**GOVERNMENT OF THE DISTRICT OF COLUMBIA**  
**DEPARTMENT OF TRANSPORTATION**

**MEMORANDUM**

**SUBJECT:** BZA Case No. 19200 – 1401 Okie St. NE – Jemal's Pappas Tomato's

Figure 5: Site Design (Source: Grove/Slade Associates)

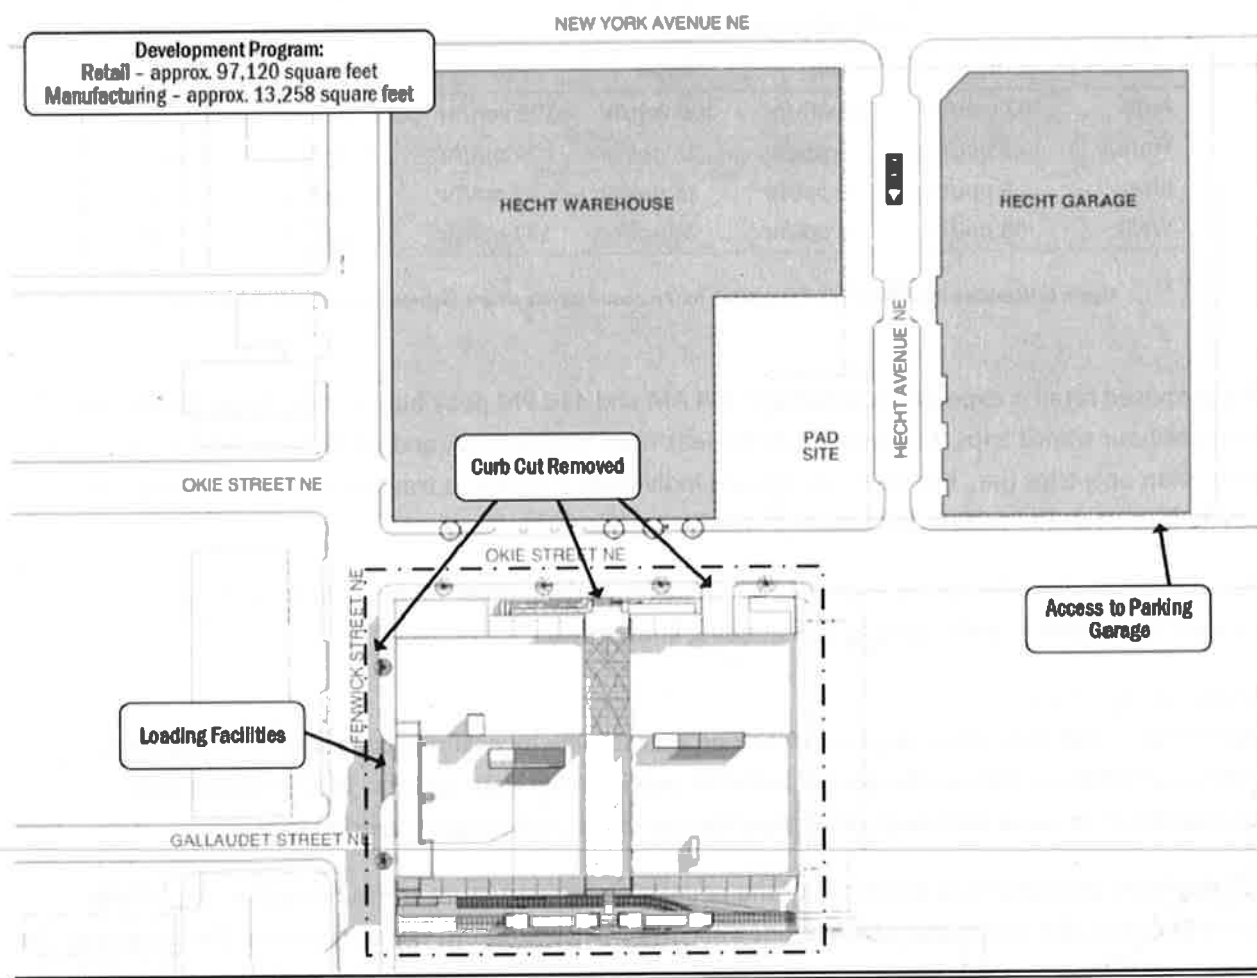
The Applicant proposes to provide the zoning required amount of loading: one 55' loading berth, two 30' loading berths, two 100 square foot loading platforms, one 200 square foot loading platform, and one 20' service/delivery space. The loading facilities are proposed to be accessed from a new 24' curb cut on Fenwick Street (see Figure 5), which will require a public space permit. Additionally, truck access will utilize backing movements in public space, which do not meet DDOT standards. DDOT is particularly concerned with back-in maneuvers at this location due to the intensity of the use of the loading facilities creating conflicts with the high number of pedestrian trips to the site and vehicle trips, as Fenwick Street is the primary route connecting New York Avenue and West Virginia Avenue. DDOT proposed to the Applicant several alternatives for loading access that would address all of DDOT's concerns without significantly impacting leasable square footage, including relocating the proposed curb cut to the south of the site to prevent all back-in maneuvers; the Applicant agreed to further explore these scenarios. DDOT expects to resolve these concerns prior to or during the public space permitting process. If DDOT's concerns are not addressed, the Applicant may need to seek additional zoning relief for loading.

While DDOT has considerable concerns with loading access on Fenwick Street, DDOT expects to resolve these concerns prior to or during the public space permitting process. As such, DDOT has no objection to the requested variance with the following condition:
